## Proposal for amendments to Regulation No. 46 (Devices for indirect vision)

The modifications to the current text of UN Regulation No. 46 are marked in bold for new characters and strikethrough for deleted characters.

Figure 3(a)

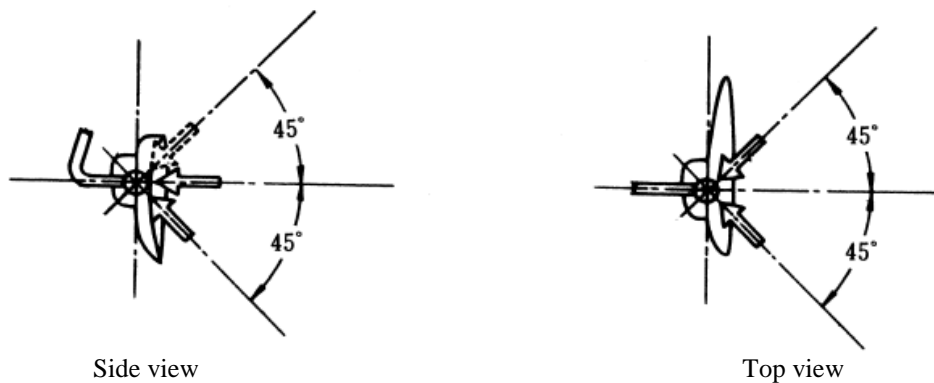
In the case of the interior mirror, apply a forward force in each of the following directions, to the centre of the rear-view mirror's direction-swivel section (see Figure 3(a)):

- (a) Direction parallel to the vehicle centre line;
- (b) Directions  $45^\circ$  to the left and right of the vehicle centre line on the horizontal plane; and
- (c) Direction  $45^\circ$  upward or downward of the horizontal line on the vertical plane parallel to the vehicle centre line.

**Figure 3(b)**

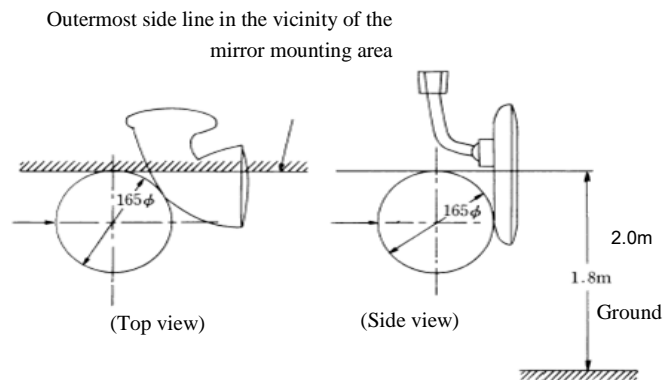
In the case of the exterior mirror, place a 165 mm diameter cylinder in such a way that the exterior of the cylinder comes in contact with the vehicle's outermost side line in the vicinity of the mirror mounting area, or the line drawn at a height of 2.0 m above the ground. Apply a rearward force in a direction parallel to the vehicle centre line, to the cylinder centre line (see Figure 3(b)).

**Figure 3(c)**

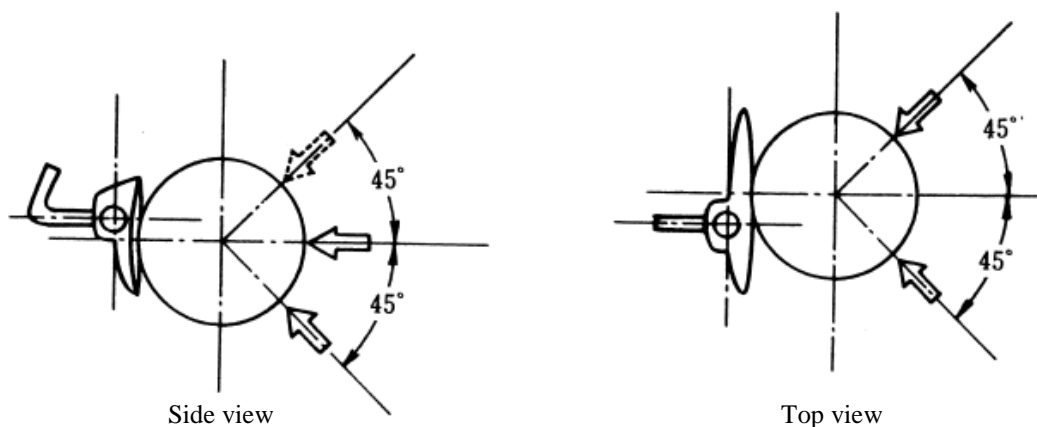
**In the case of the interior mirror, place a 165 mm diameter spherical object in such a way that it comes in contact with the mirror surface centre, and apply a forward force in each of the following directions, to the spherical object centre (see Figure 3(c)):**

- (a) Direction parallel to the vehicle centre line;
- (b) Directions  $45^\circ$  to the left and right of the vehicle centre line on the horizontal plane; and
- (c) Direction  $45^\circ$  upward or downward of the horizontal line on the vertical plane parallel to the vehicle centre line.

Figure 11 Class IX Front and Close-proximity Passenger-side field of vision

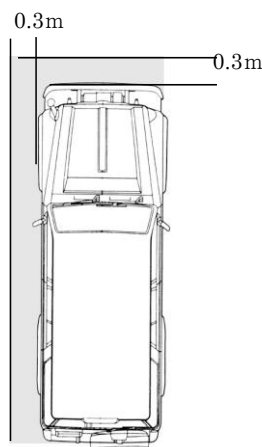
In vehicles of category M, a cylinder with a diameter of 0.3 m and height of 1.0 m that is in contact with the vehicle's front side and the lateral side on the passenger's side shall be partially visible using direct field of vision or any mirror including the surveillance mirror (see Figure 11). In this case, the eye-points in the direct field of vision are determined in Annex III. However, the blind area created by the A-pillar or exterior rear-view mirror as specified in Annex IV is excluded. If the field of vision cannot be achieved using these options, it may be achieved through installing a camera-monitor device, provided that it is easy to control the device to display images.

Figure 1

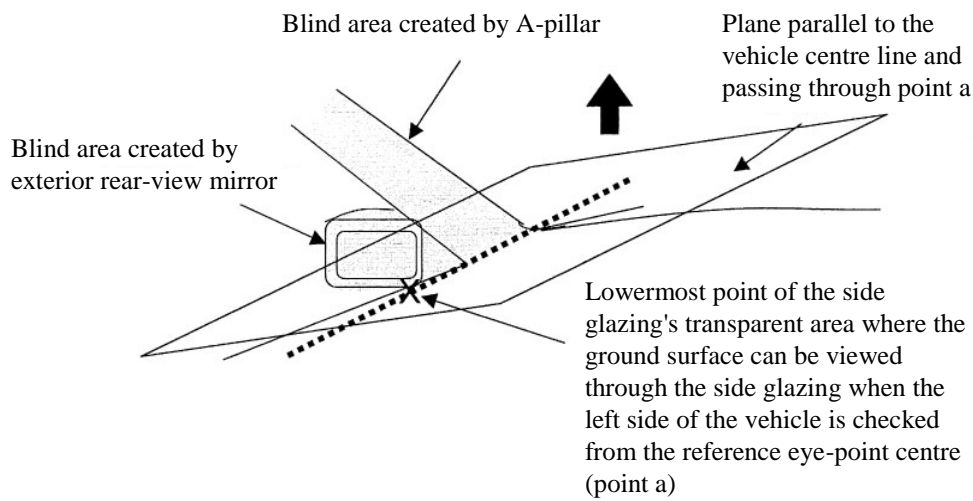
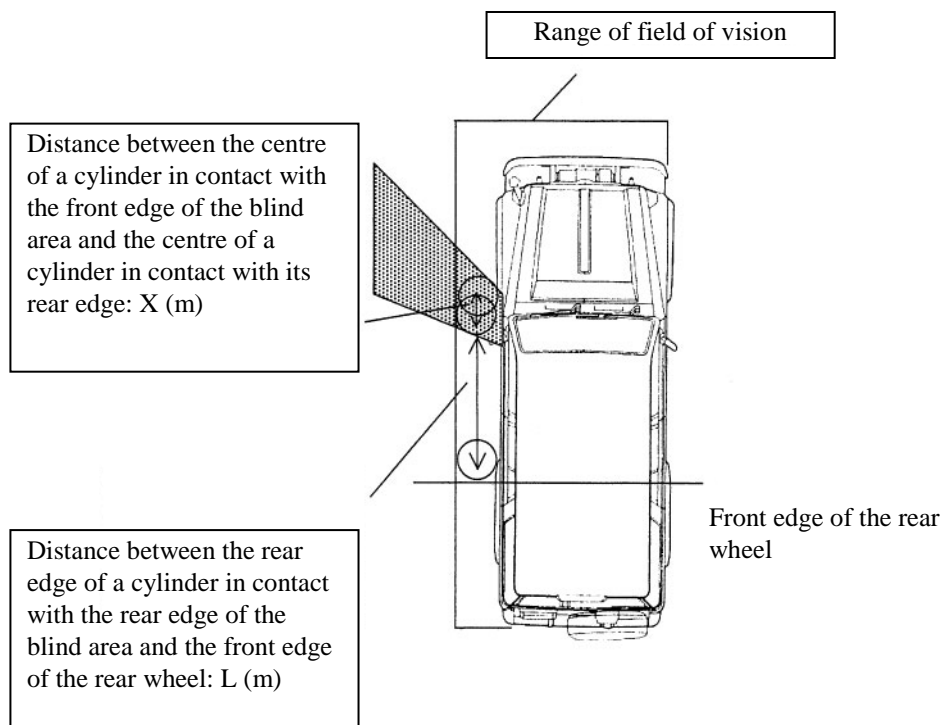
The range of the blind area created by the A-pillar or exterior rear-view mirror in paragraph 15.2.4.10. shall be an area that meets the following formula. In this case, if there are more than one blind area, each blind area shall meet the conditions of the formulae.

$$X \leq 0.292 \cdot L - 0.203$$

**X (m):** is the limit of the excluded area, i.e. the distance between the centre of a cylinder in contact with the front edge of the blind area and the centre of a cylinder in contact with its rear edge.

**L (m):** is located inside the blind area created by the A-pillar or exterior rear-view mirror. Distance between the rear edge of a cylinder in contact with the rear edge of the blind area and the front edge of the rear wheel.
